Tennessee Valley Authority, Watts Bar Nuclear Plant, Unit 2
Docket No. 50-391

**Subject: Revised Response to Request for Additional Information
Question 3 Regarding Final Safety Analysis Report Section 2.4
(TAC NO. ME3945)**

ENCLOSURE 2
REVISED FSAR FIGURE 2.4-72

UFSAR Amendment I
 WATTS BAR NUCLEAR PLANT
 FINAL SAFETY
 ANALYSIS REPORT
 EMBANKMENT
 RESULTS OF ANALYSIS FOR
 OPERATING BASIS EARTHQUAKE
 Fort Loudoun Dam
 Figure 2.4-72

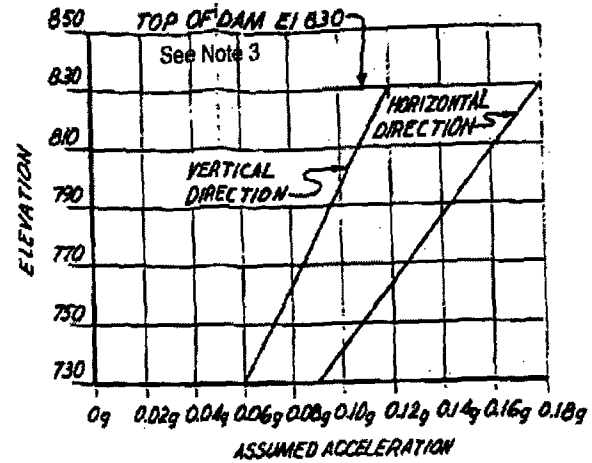
Regarding the RAI question 2 response submitted in the referenced letter, TVA agreed to revise FSAR Figure 2.4-72 to show the sand baskets. An FSAR Change Request has been submitted to include this revision in FSAR Amendment 104. A copy of the Figure submitted with the Change Request is provided in Enclosure 2. Note 3 was added to Figure 2.4-72 to describe the sand baskets.

- NOTES:
1. Analysis was made using the standard slip circle method.
 2. Shear strengths of materials same as used in original analysis.
 3. Improvements have increased the effective height of the embankment to a minimum EI 836 (See Fort Loudoun Project Drawing 10W222-1). Field surveys indicate a minimum height of EI 836.9 was achieved.
